SUNDRY NOTICES AND REPORTS ON WELLS (DO NOT USE THIS FORM FOR PROPOSALS TO DRILL OR TO DEEPEN OR PLUG BACK TO A DIFFERENT RESERVOIR. USE "APPLICATION FOR PERMIT" (FORM C-101) FOR SUCH PROPOSALS.)	
1. Type of Well: Oil Well ☐ Gas Well ☐ Other ☐	
2. Name of Operator Harvey E. Yates Company	
3. Address of Operator PO Box 1933, Roswell NM 88202-1933	
4. Well Location Unit Letter <u>E</u> : <u>1980</u> feet from the <u>North</u> line and <u>660'</u> feet from the <u>West</u> line Section <u>22</u> Township <u>23 S</u> Range <u>27 E</u> NMPM <u>Eddy</u> County	
11. Elevation (Show whether DR, RKB, RT, GR, etc.) 3148.6' GL

We propose to plug and abandon the Amoco 22 State #1 as follows:

Amoco 22 State #1
 #30-015-22450 (St/ise L-711)
 API #30-015-27185
 E-22-T23S-R27E, Eddy Co, NM
 1980' FNL & 660' FWL
 Prop ID #037720-001
 3148.6' GL (15.4' kb)
 Harvey E. Yates Company

Wellbore Status as of : 06/12/03

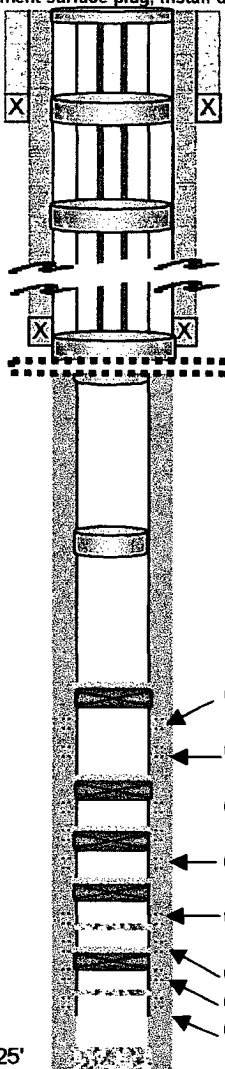
Salt gel mud consisting of 10#
Brine W/25# of gel per bbl
must be placed between each plug

1. Circulate 9# mud.
2. Spot ~~100'~~ cement plug from ~~7,050' - 6,950'~~ 255K plug @ 8960'
3. Cut & Pull approximately 5,700' casing. SS18'
4. 2321 Spot ~~200'~~ cement from ~~5,750' - 5,550'~~ (50' in & out of cut csg & cover csg shoe). Tag plug.
5. Spot 100' cement from ~~2,500' - 2,400'~~ 2100' - 2200'
6. Spot 100' cement from 425' - 325' to cover csg shoe. - Tag
7. Set 20 sx surface plug. Install dry hole marker. - WOC 24 HRS - Tag

* - 100' plug 1897-1997 - Tag
* - 100' plug 1096' - 1196' - Tag
